ASSESSMENT REPORT

Section 75W Modification Vincentia District Town Centre (MP06_0025 MOD 6)

Figure 4: Proposed Stage Piped Drainage System and Bioswale

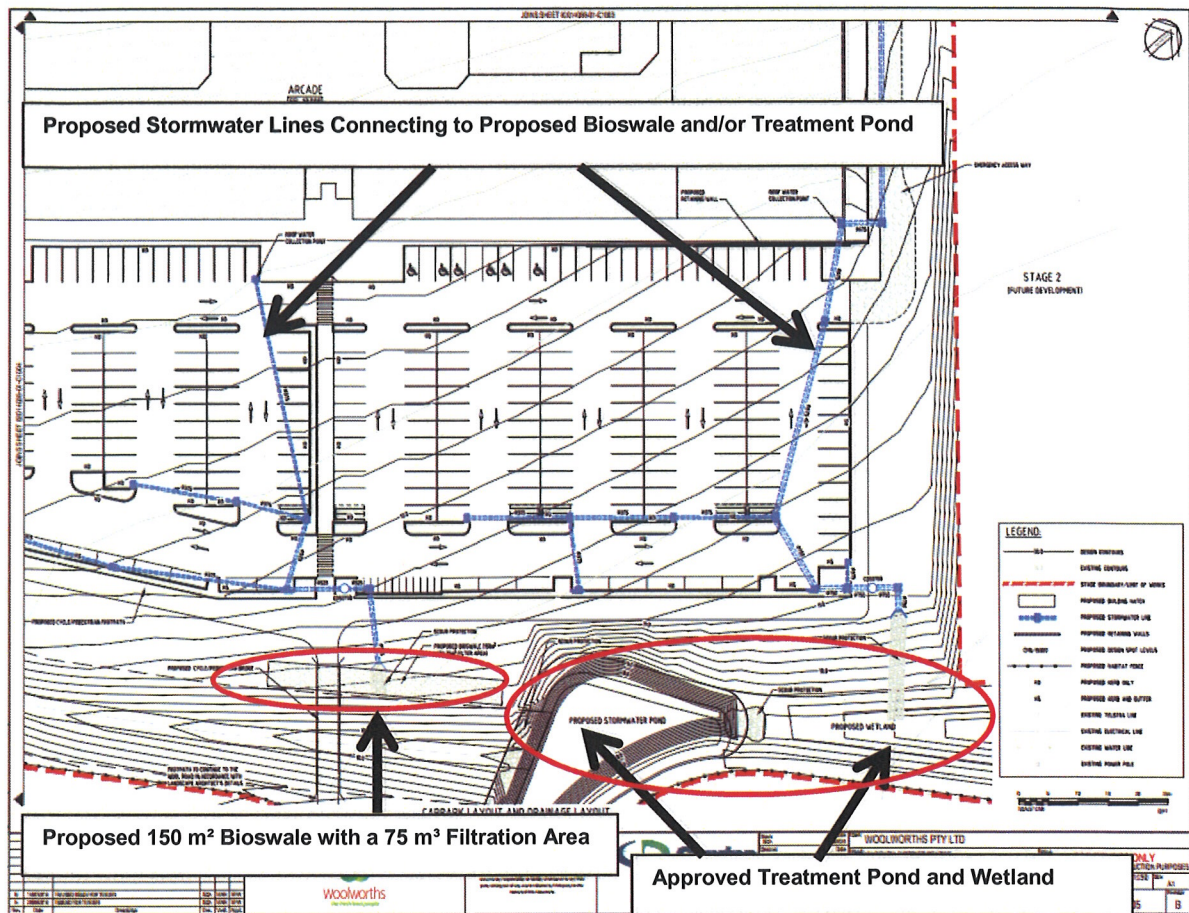
The application originally sought approval to remove the landscaped swales within the car park and replace them with GPTs. This modification was requested to provide a level car park surface to minimise the risk of property damage and accidents associated with trolley 'roll', and to reduce system failure associated with garbage being deposited in the bioswales in the car park area.

Both Council and the OEH raised concerns with this aspect of the modification on the basis that the absorption and filtration rates of GPTs provide an inferior water quality outcome in comparison to landscaped swales. In addition, both agencies were concerned that the modifications to the approved stormwater management strategy would be inconsistent with the water sensitive urban design principles approved under the Concept Plan.

In response to the concerns raised by the Council, OEH and the Department, the Proponent's RTS clarified that the application is seeking approval to remove the landscape swales within the car park and divert these water flows to a 75 m³ biofiltration area adjacent to the car park and the approved stormwater pond and wetland (see **Figure 4** below). In addition, the RTS noted that following initial treatment in the bioswale, stormwater would be transferred to the approved settlement pond prior to release further downstream as anticipated under the approved stormwater management strategy

- whilst the application removes the bioswales located within the car park, stormwater flows will be diverted to a 75 m³ bioswale immediately south of the car park thereby ensuring the treatment of water in accordance with the water sensitive urban design principles approved under the Concept Plan;
- whilst the design excellence provisions identified in Condition A4 of the Concept Plan require the incorporation of impervious surfaces within the car park to enable water infiltration, the Department is satisfied that the proposed modification provides an equivalent water treatment solution, and therefore the development will continue to exhibit design excellence; and
- there will be no unreasonable impact to sensitive downstream receiving waters resulting from the removal of the car park bioswales.
